Poeton Industries
Poeton Cardiff Ltd.
283 Penarth Road
Cardiff
CF11 8UL

FAO: Mr. Jason Hamling
Report Reference: Audit of secondary containment measures at Poeton in Cardiff – January 2026
Report Ref. No: PR9965

GPT (UK) Ltd - Bund Audit Report

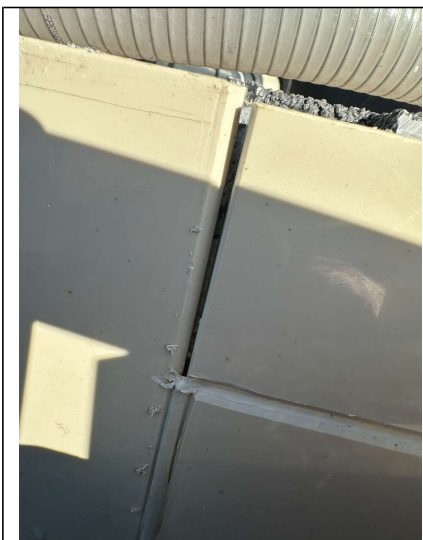
Image 7. Plastic sump liner not attached to the main body of the bunded area with a significant gap visible between the two pieces.	Image 9. Large hole between the plastic sump liner and the bottom of the bunded area. Existing degraded brickwork sump visible.

Image 10. Large gap visible between two joints forming the bund walls.

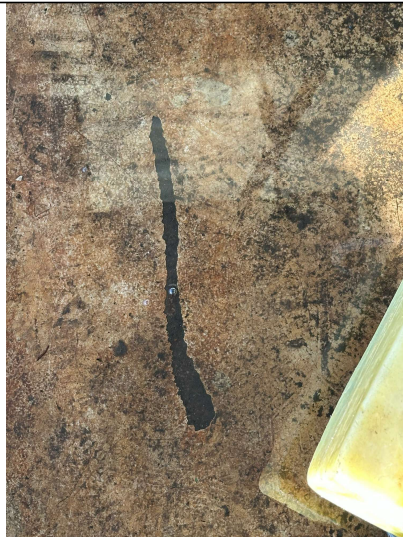
Image 6. Cracks to the bund wall to the rear of the concrete structure (rear, right hand side).

Image 7. Damage to the bund lining from scrpaing of forklift attachments or pallet truck.

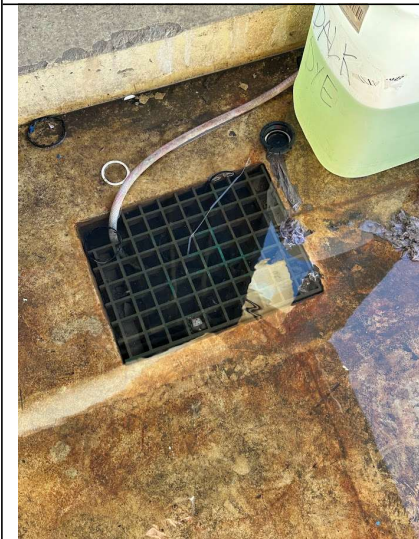
Image 8. Damage to the bund wall from forklift impact (suspected wheels when turning).

Image 9. Sump to the front of the bund which appears to be holding water.

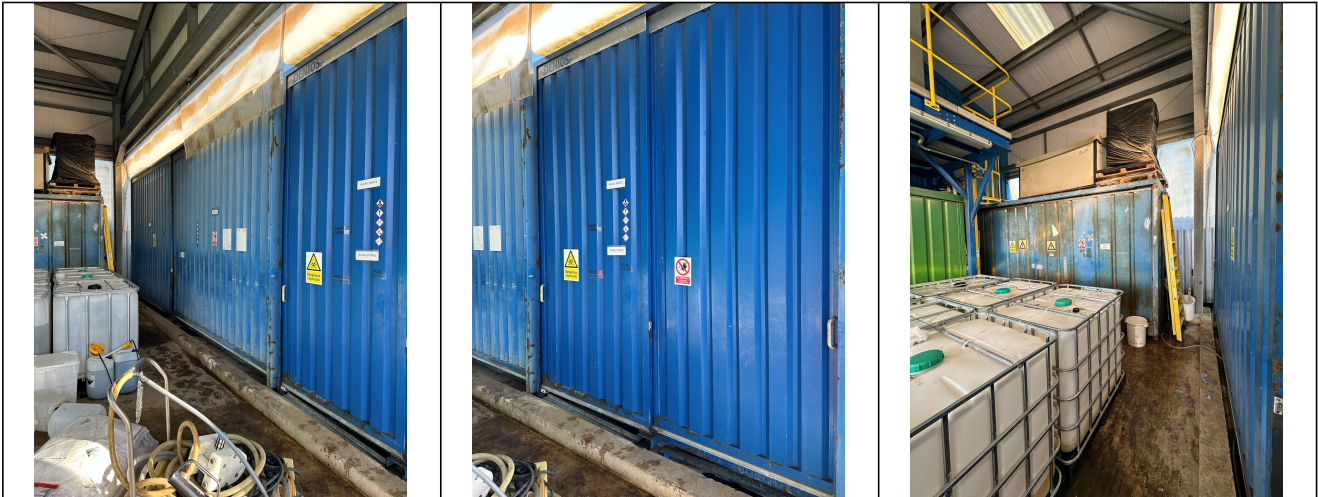
Image 14. Unsealed gap between the bund floor and the external concrete pad - pollutant pathway.

Image 15. Chemical storage cabinets which are external to the bunded area.

Image 17. The two chemical storage cabinets which should be used to prioritise liquid storage.

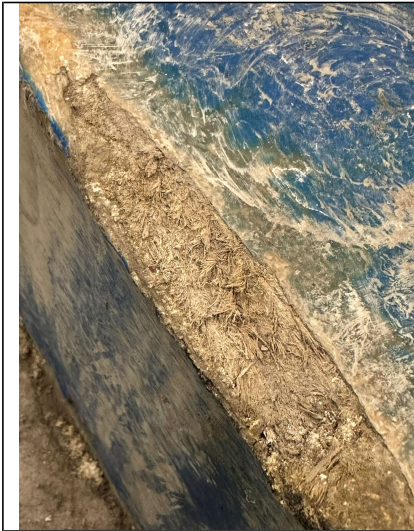
Image 4. Drainage channel passing through the warehouse floor and discharging to bund 2 (externally). Image 5. Drainage channel passing through the warehouse floor and discharging to bund 2 (externally).

Image 6. Fibrous material exposed due to prolonged chemical exposure.

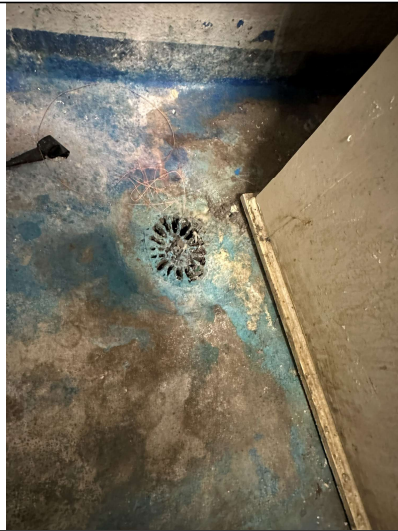
Image 7. Floor drain located within the confines of the bunded area.

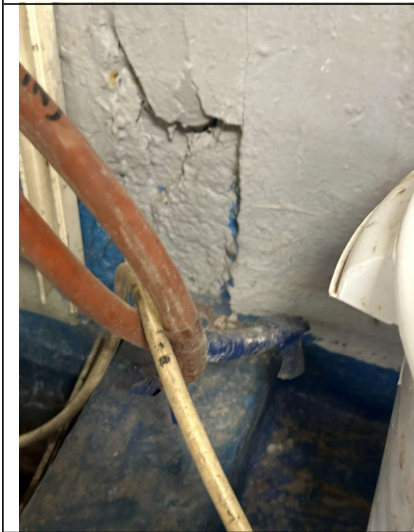
Image 9. Delamination of the render to the bund side of the internal wall.

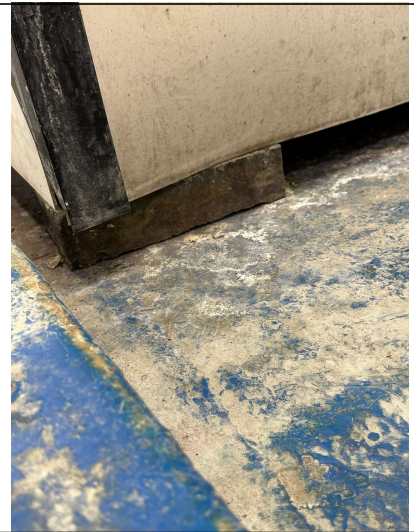
Image 10. Heavy chemical staining and damage to the warehouse floor. Many cracks visible.

Image 11. One of the tanks within the bund which was positioned on acid-resistant engineering bricks.

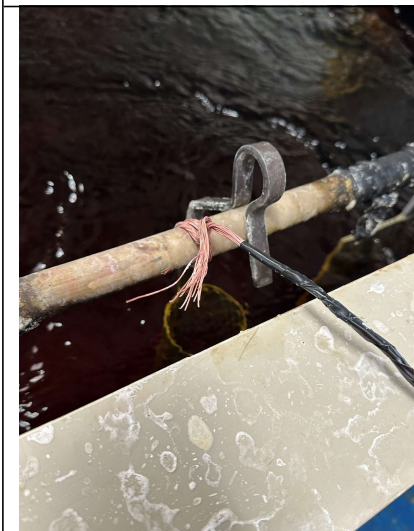
Image 12. Exposed copper cable above the chromium tank.
